## Avon Parks – Burnett Park and Winton Meadows Park Addendum 02

DATE: Friday, February 20, 2026

PROJECT NAME: **Burnette Park and Winton Meadows Park**

The extent of this addendum is as follows:

Project Number 2020.01413

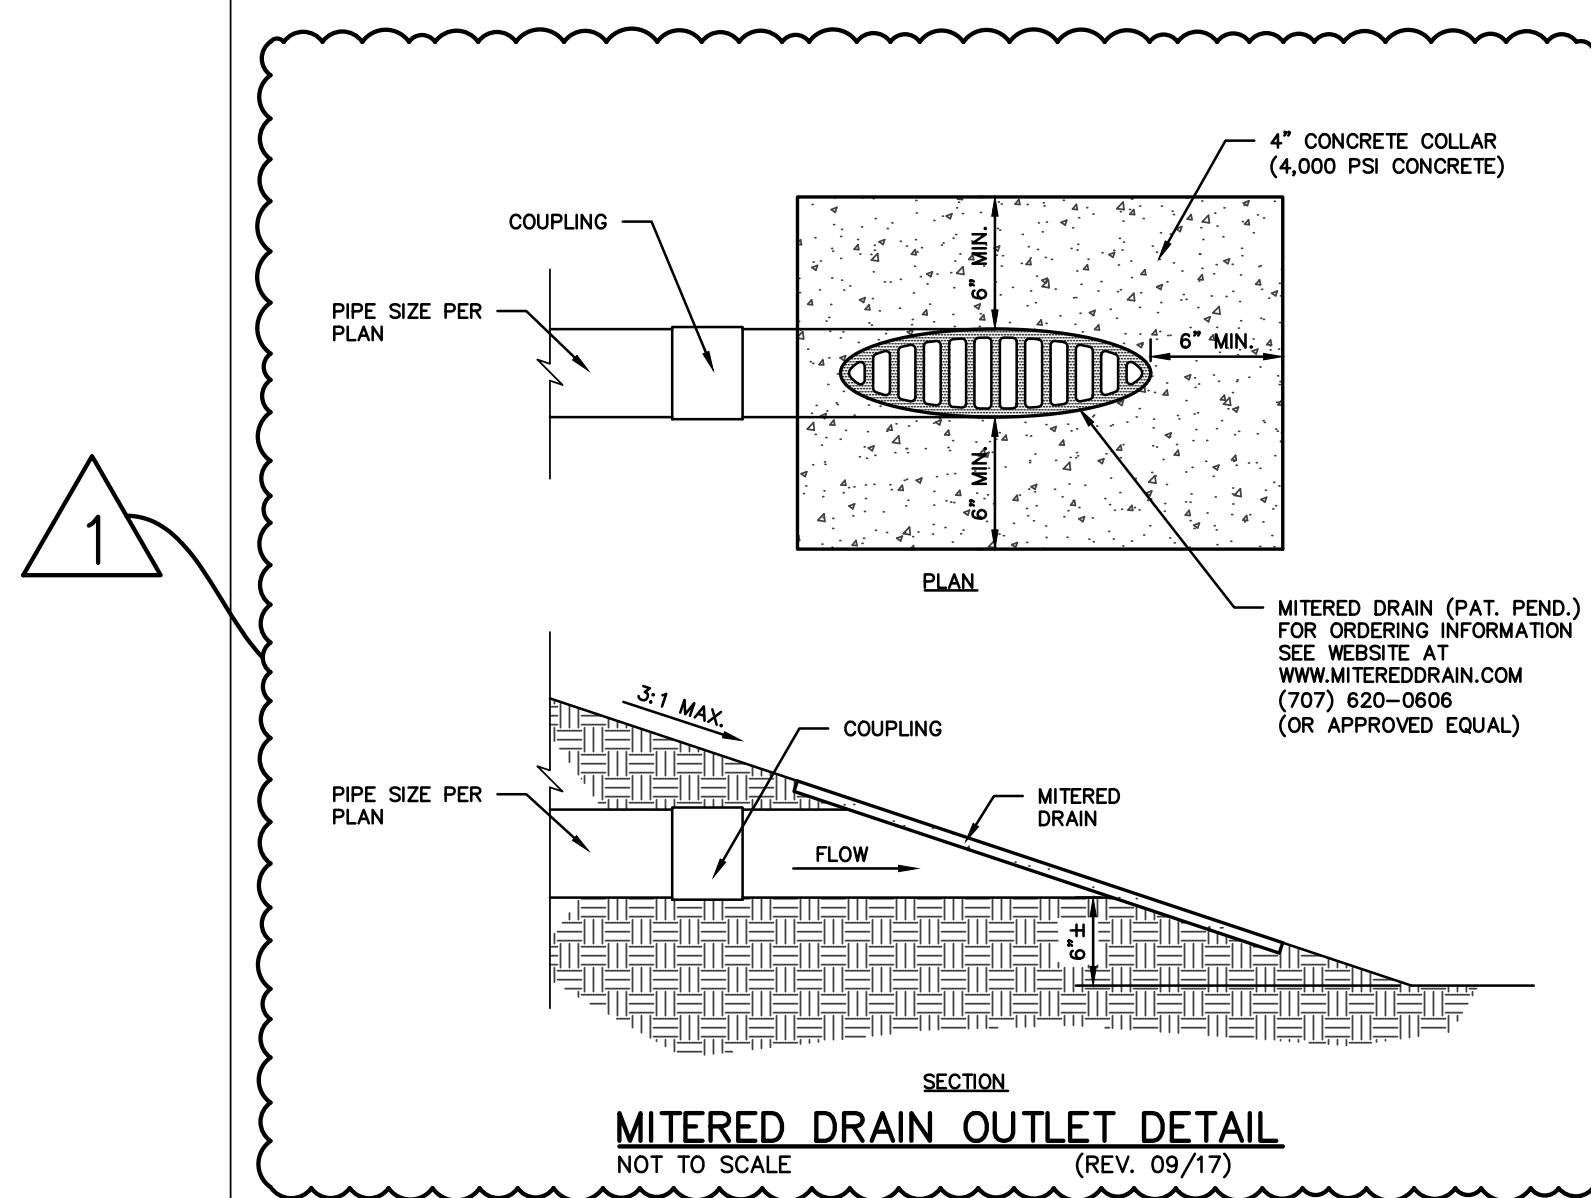
- a) STR 101 revised to inlet. Granular backfill shown from 101-102.

**4 CURB, INTEGRAL SIDEWALK**  
 Scale: 3/4" = 1'-0"

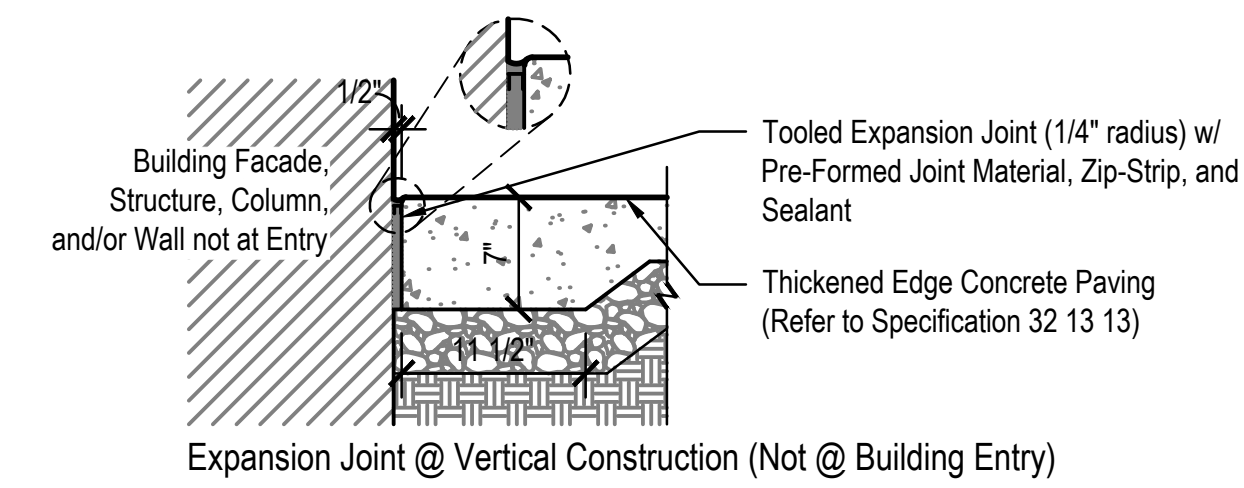
- a) Remove WWM from Integral Sidewalk Curb Detail

**1 BIOSWALE STEPPING STONES PLAN**  
 Scale: 1/4" = 1'-0"

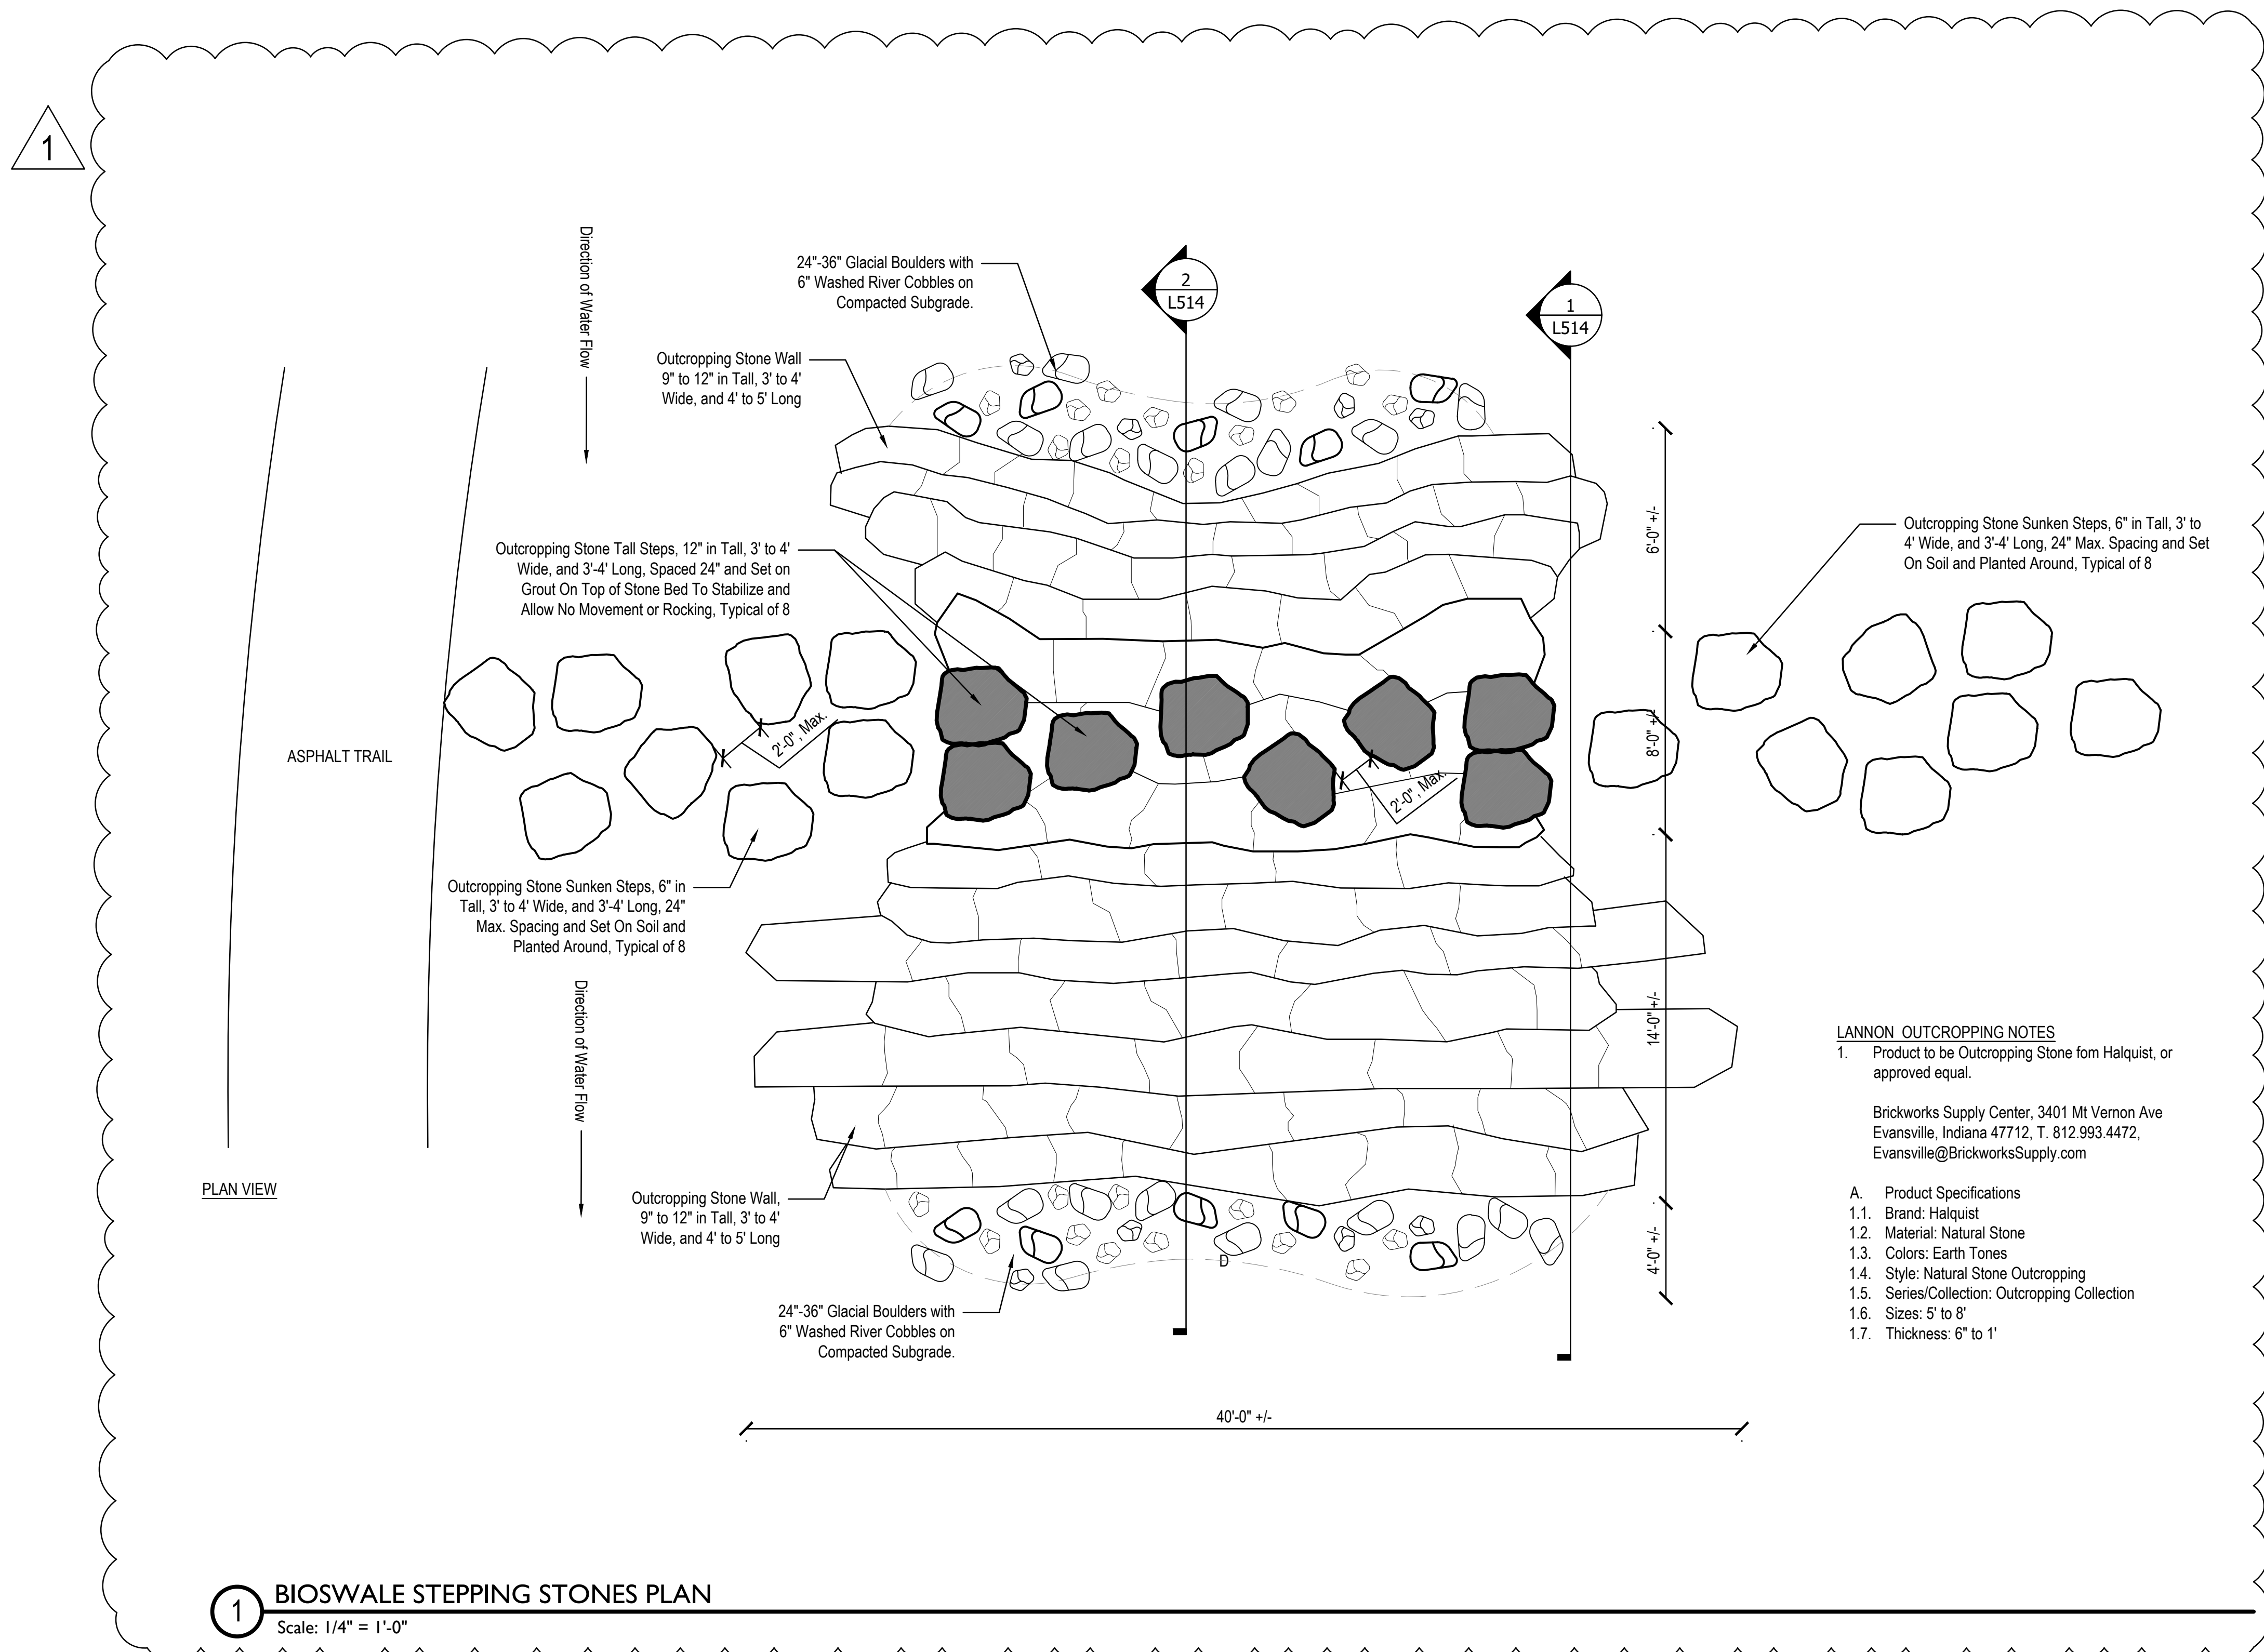
- a) Updated bioswale stepping stone plan.
